SABINE RIVER AUTHORITY OF TEXAS

TOLEDO BEND UNDERWATER STUMP REMOVAL RFB# 24-1201

THIS ADDENDUM IS ISSUED FOR THE PURPOSE OF AMENDING THE CONTRACT DOCUMENTS FOR THE SABINE RIVER AUTHORITY OF TEXAS, AS FOLLOWS:

Proposed Removal Area
(31deg, 24.56 min N; 93deg, 44min W)

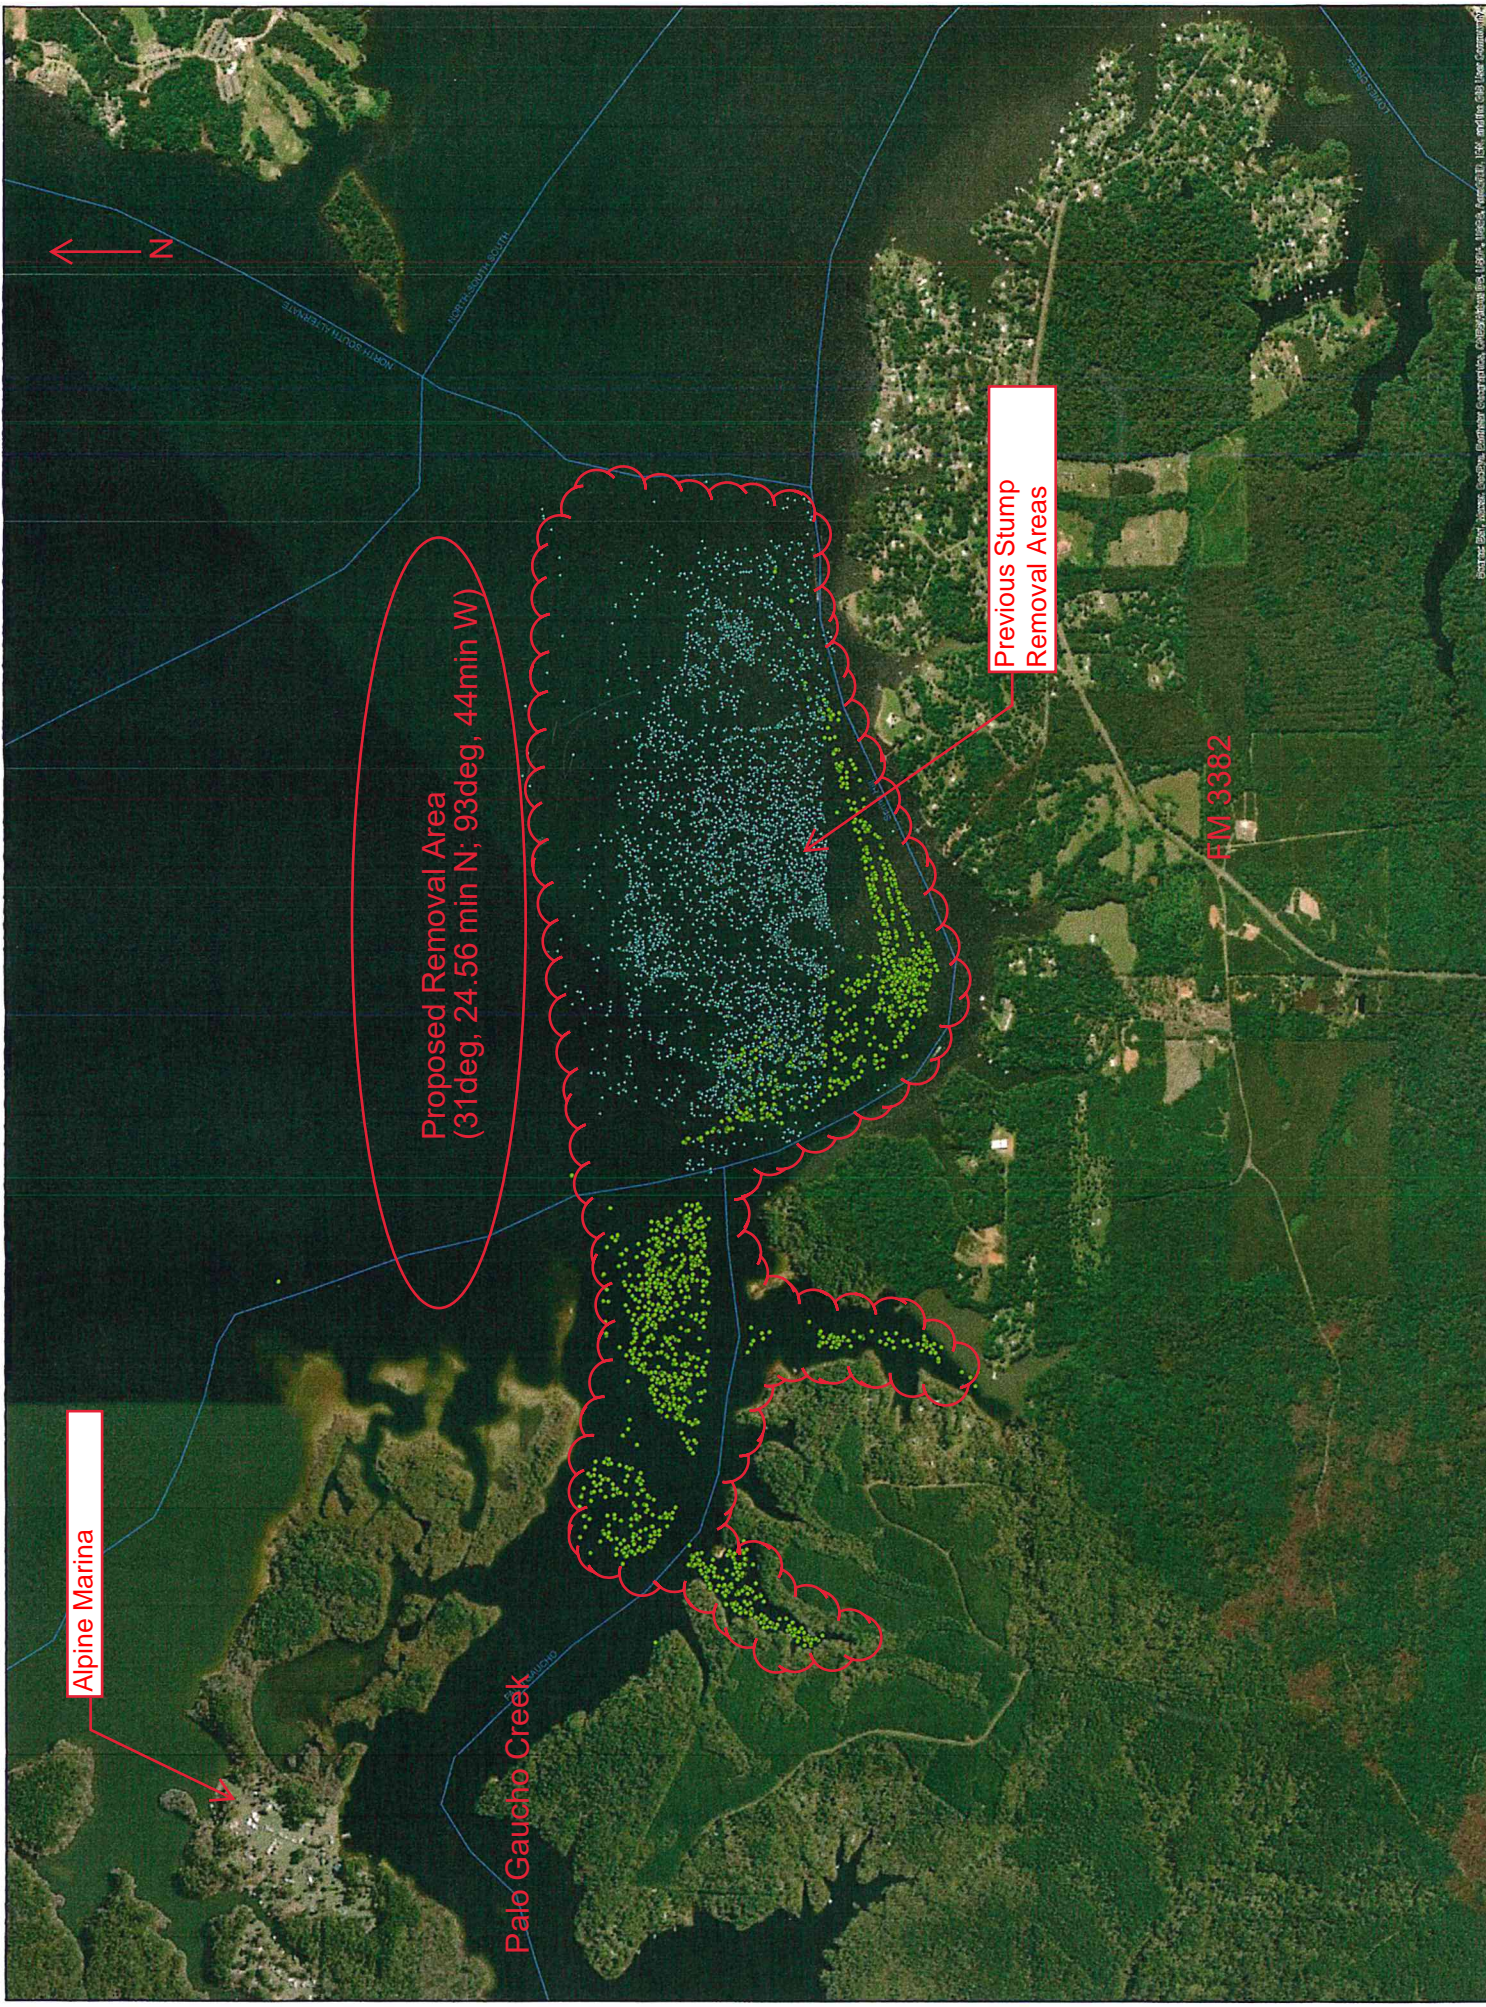
- Is there a more detailed location map?
 - Please see the updated location map.
- Will a copy of the Pre Bid Attendance roll be made available?
 - See the attached copy of the sign in sheet for the pre bid.

- Will the GPS coordinates of the area to be worked be provided?
 - SRA crews will provide coordinates of the areas to be worked prior to starting. The general location is 31°24'56.89"N; 93°44'4.23"W .
